| NO: Sw - 158 | PRODUCT: B3FS-4 series – Tactile Switch |
| DATE: February 2026 | TYPE: MODIFICATION – Lot Code Marking and Base Mold Gate change |

B3FS-4 series Tactile Switch - Lot Code Marking and Base Mold Gate change

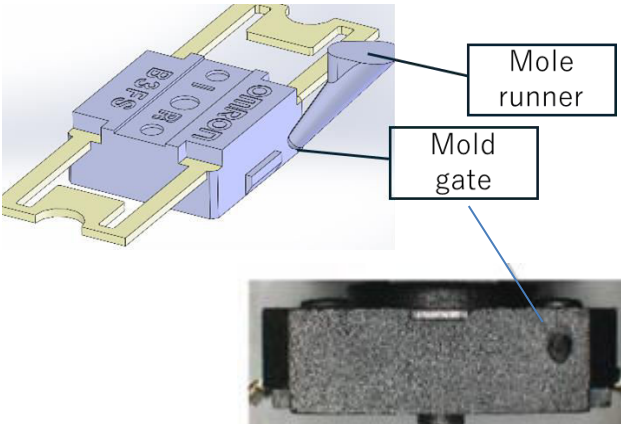
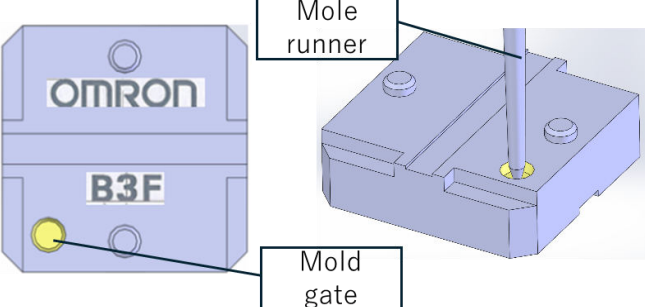
| Before the change | After the change |
|---|--|
| <p>Lot Code Marking</p> <p>Position: Top side on cover</p> <p>Number of digits: Two-digit notation</p> <p>Marking method: Engraving</p>  | <p>Lot Code Marking</p> <p>Position: On side of Base part Removed from top side on cover</p> <p>Number of digits: Seven-digit notation</p> <p>Marking method: Laser</p>  <p>Lot Code decoding:</p> <p>A : Day 01,02,03···30,31 B: Month 1,2,3,···X(10),Y(11),Z(12) C: Year (The last character of the year notation.) D: Code of Production site E: Management number F: Management number</p> |

| Before the change | After the change |
|---|--|
| <p>Molded gate Position: On side of base</p>  | <p>Molded gate Position: On bottom of base</p>  <p>Note: Gate position subject to change.</p> |
